APPLICATION NO.	FILING DATE	FIRST NAMED INVENTOR	ATTORNEY DOCKET NO.	CONFIRMATION NO.
10/756,714	01/13/2004	Paul Halas	5034-103 US	2905

Office Action Summary

Claim Rejections - 35 USC § 102

PATENT COPY WITH ANNOTATIONS

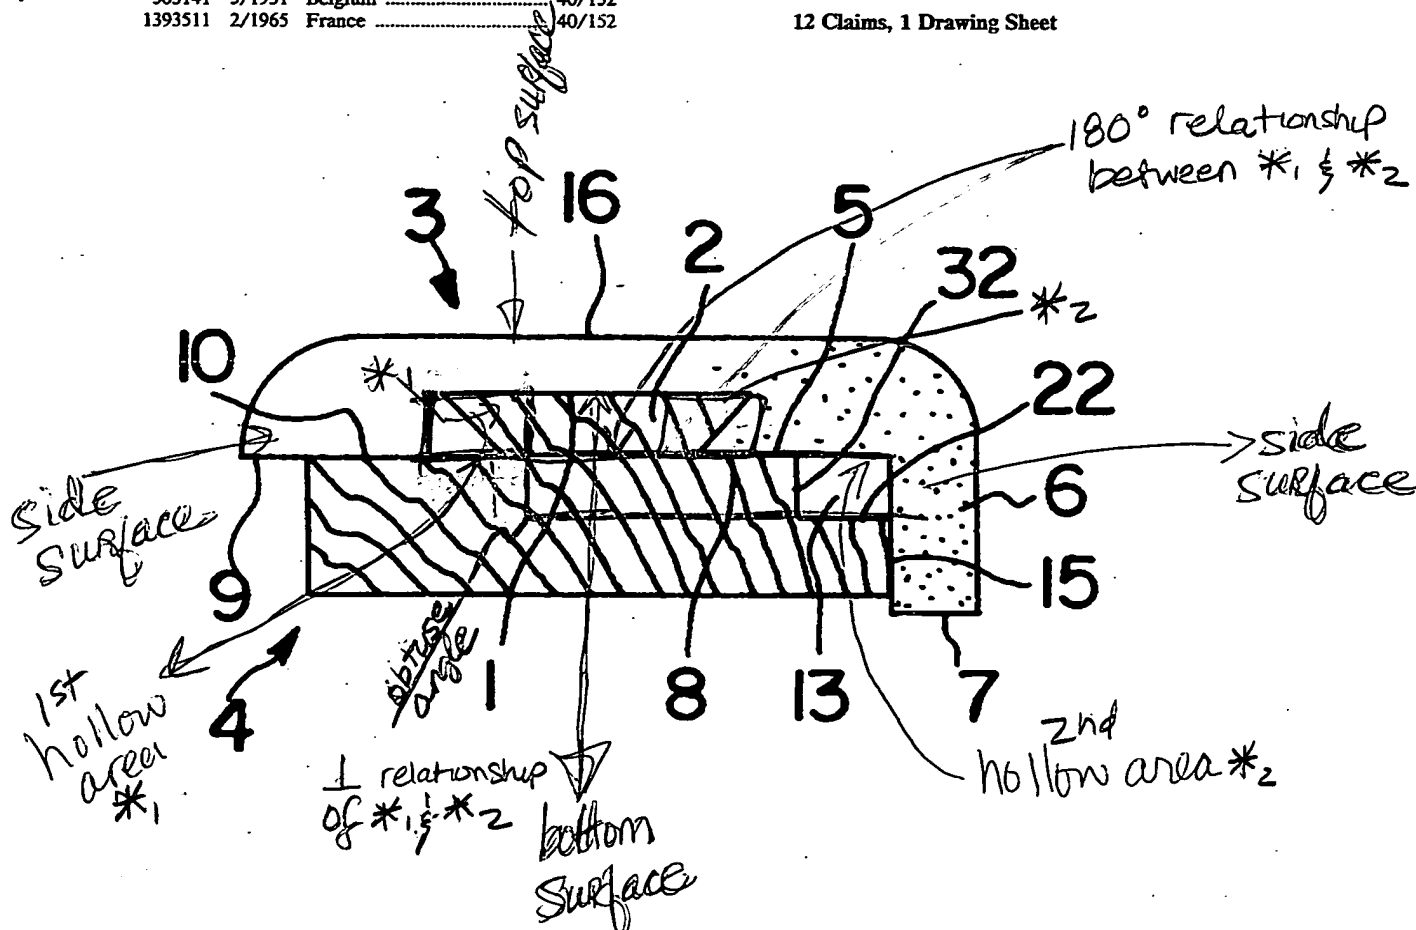
- A top surface 16;
- A bottom surface 1;
- Side surfaces ; the side surface coupling the top to the bottom surface; see figure 5; see annotations on patent copy;
- The side surface having a first hollow area corresponding to the first cross sectional area and a side surface having second hollow area corresponding to the second cross sectional area; the cap goes over the joint 24/24a and hence covers portion 4 and 4a;
- The first and second molding 4 and 4a is covered by a three dimensional structure; see figures 4 and 5; the cap 3 has a three dimensional structure that straddles the first and second molding. The cap and the three

- The side surfaces comprise a plurality of mostly flat surfaces with first and second hollow areas; see annotations on patent copy; the first hollow area is approximately 90 degrees relative to the second hollow area;

- The first hollow area is oriented approximately 180 degrees relative to the second hollow area; see annotations on patent copy;
- The first hollow area is oriented at an obtuse angle relative to the second hollow area; see annotations on patent copy;

- The first and second hollow areas define mirrored areas; see annotations on patent copy;
- The first hollow area and the second hollow area extend into 3-D structure at least as large as the corresponding area defined at the side surface; see figure 5;
